P98-053

Attachment C
NOTICE OF DECISIONS AND FINDINGS OF FACTS

NOTICE OF DECISION AND FINDINGS OF FACT FOR THE RALEY BLVD/SANTA ANA AVENUE STORAGE/OFFICE BUILDING PLAN REVIEW AND VARIANCE, LOCATED AT THE NORTH-EASTERN CORNER OF RALEY BLVD AND SANTA ANA AVENUE, IN NORTH SACRAMENTO, CALIFORNIA IN THE LIGHT INDUSTRIAL (M-1R) ZONE. (P98-053)

EXHIBIT C-6

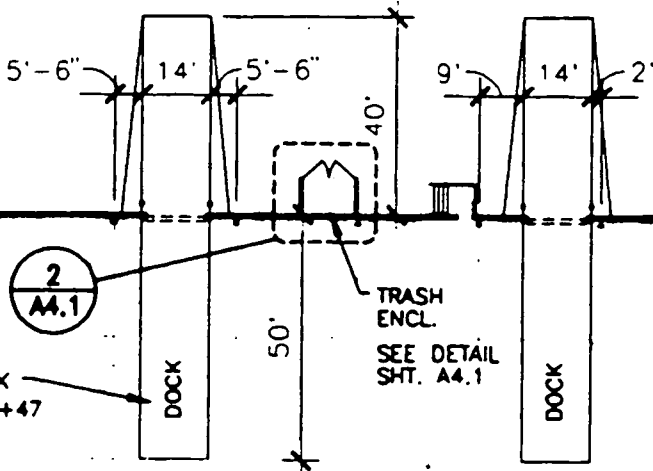
- C27. Prior to issuance of building permit, applicant shall submit a site plan to the **Planning Director** showing the ~~existing and~~ proposed improvements on **the attached Exhibit C-6 in the areas indicated as A, B, C, and D. These include the addition of an additional parking space (A) to replace the deleted space (B), placement of a "DO NOT ENTER" sign (C) and the widening of the driveway off of Santa Ana Avenue from 35 feet to 45 feet (D). ~~both sides of Raley Blvd. and Santa Ana. Include center lines, right-of-way lines, curb, gutter, sidewalk and driveway cuts.~~**
